Commonwealth Edison Company
LaSalle Generating Station
2601 North 21st Road
Marseilles, IL 61341-9757
Tel 815-357-6761

Subject: LaSalle County Nuclear Power Station Units 1 and 2
Submittal of Additional Information discussed during
Conference Calls Regarding Modifying the Main Steamline
Tunnel Automatic Isolations
NRC Docket Nos. 50-373 and 50-374

Attachment A

Attachment B

Attachment 2
Upper MST Temperature
following loss of VR on
8/25/95
(95°F inlet)

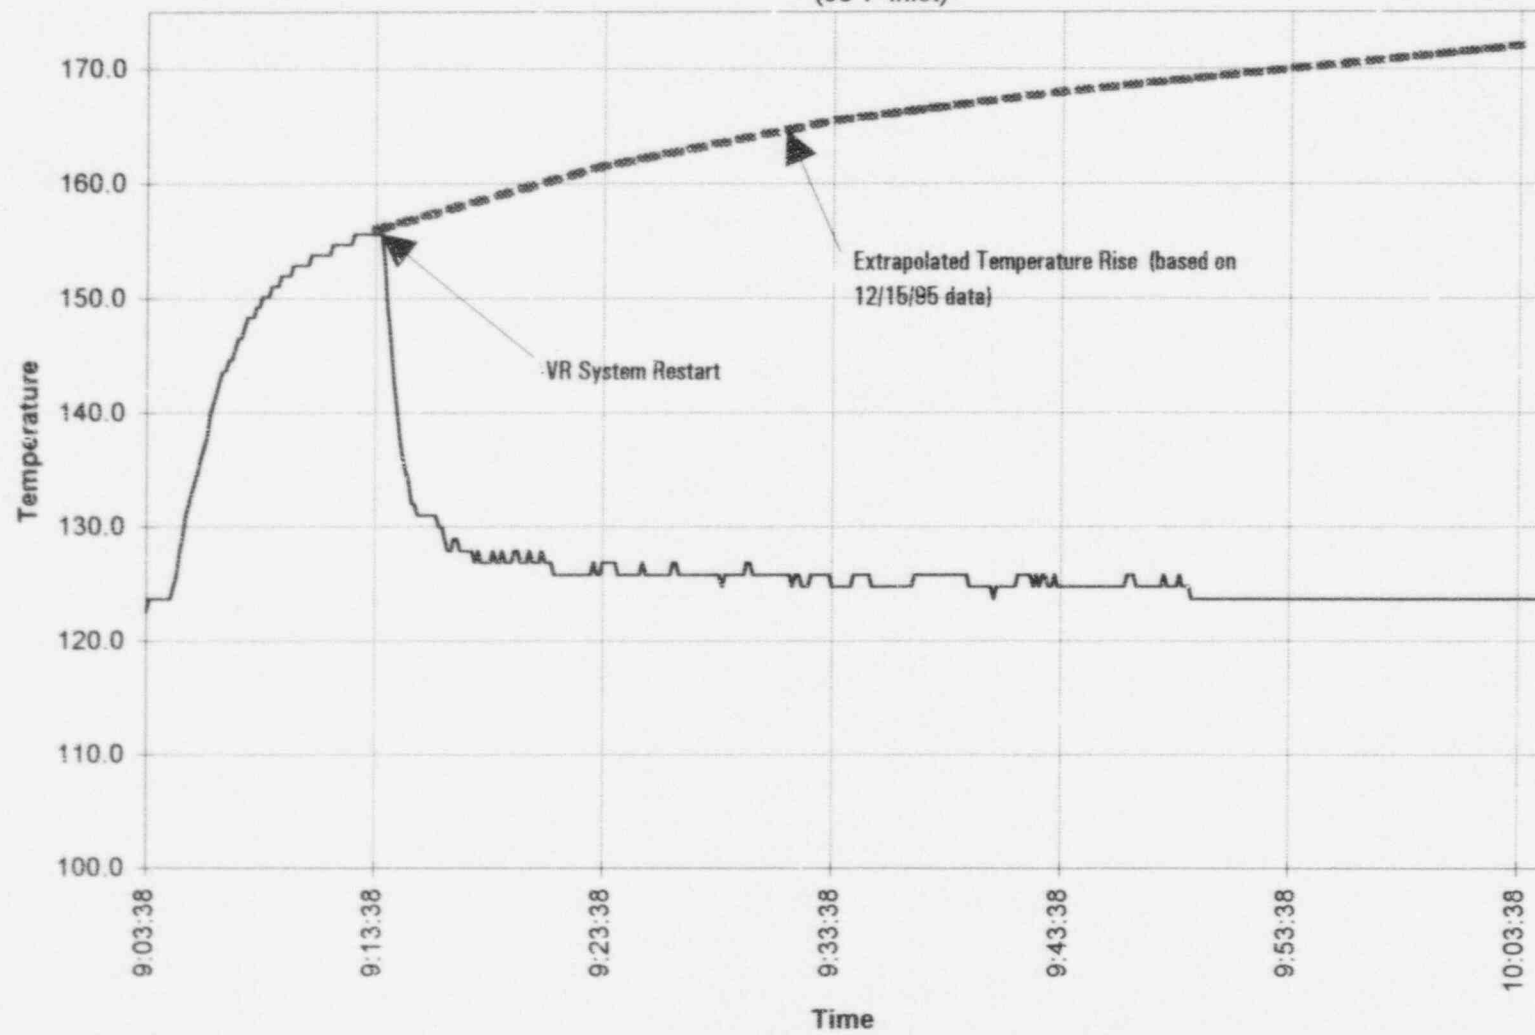
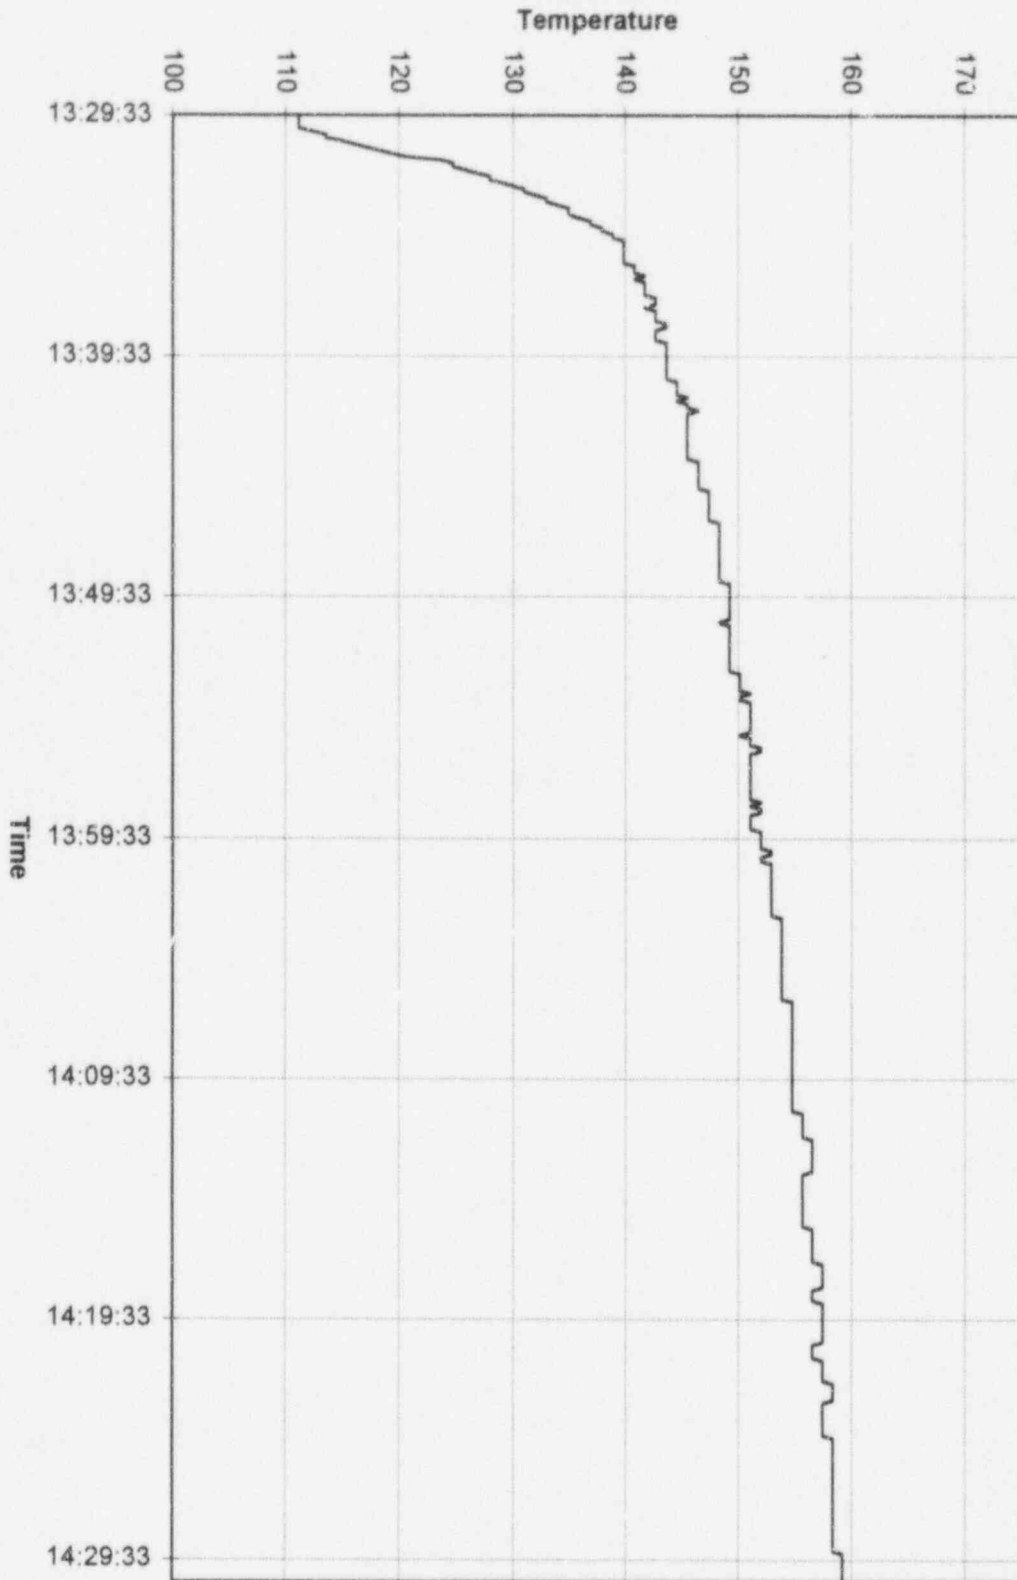
Describe the 8/25/95 and 12/15/95 events.

How was the data from the 8/25/95 event extrapolated?

Attachment 2 and 3 indicate the upper MST temperature response following a loss of VR for the subject dates. VR was manually secured on both of these dates for planned surveillance testing. The data was collected for use on this project.

The 8/25/95 data was extrapolated following VR system restart by projecting the response curve from the 12/15/95 event onto the 8/25/95 data curve. This extrapolation should be reasonable for estimating required operator response times. Note that the shape of the 8/25/95 curve and the 12/15/95 curves are identical from the time of initiation until the 8/25/95 event was terminated at the 10 minute mark. The only difference between the two curves is that the 8/25/95 curve is raised by 14°F which corresponds to the difference in VR inlet temperature on those two days.

Figure 5: Upper MST Temperature due to Steam Leakage

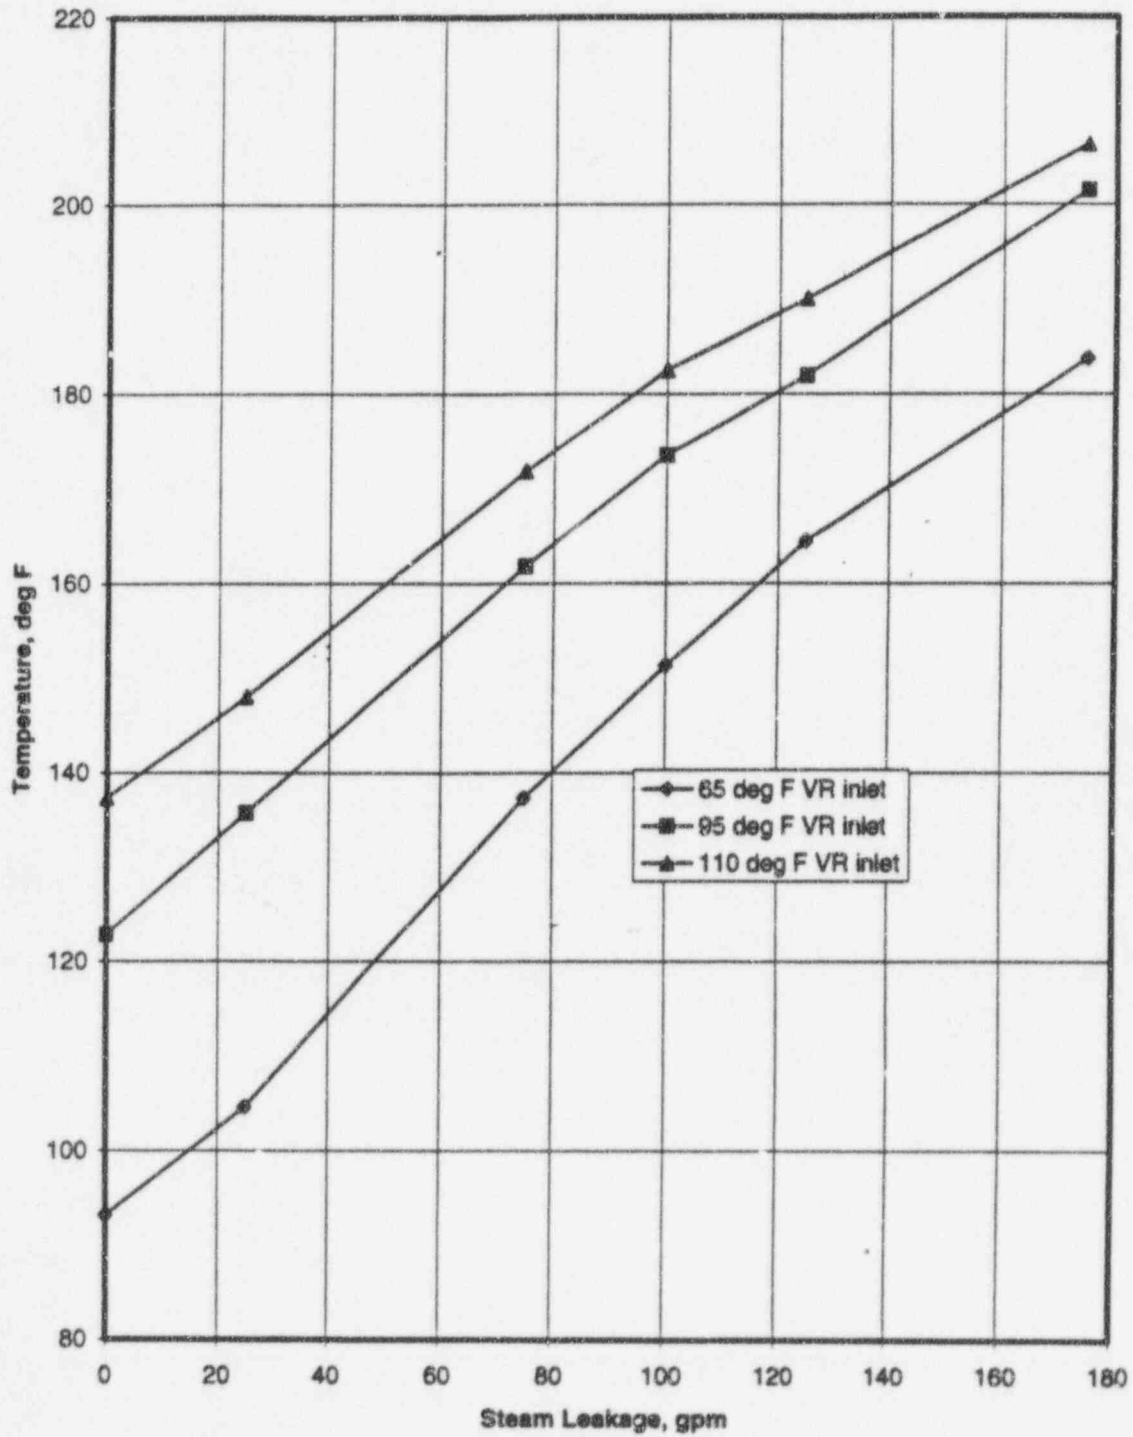
During the 3/14/96 Telecon with the NRC, ComEd was asked to address two areas of concern. (1) Is it possible to keep the high temperature automatic isolation function, based on the 100 gpm leak value, without requiring heroic operator actions on loss of Reactor Building Ventilation (VR), to prevent a Group 1 Main Steam Line Isolation and unit SCRAM? (2) Will the changed Technical Specification values jeopardize the environmental qualification of any equipment in the MST?

We also considered a setpoint based on ensuring the operators have a minimum of 30 minutes before taking required action after a loss of VR. This setpoint would start with 166°F (from Attachment 2) add 15°F for the instrument error band and add another 15°F for the 110°F design inlet condition. This would give a setpoint of 196°F. During the winter design conditions no isolation would occur until the leak was greater than 200 gpm (Attachment 4 extrapolation). Again, this would not be conservative with respect to the 100 gpm criterion.
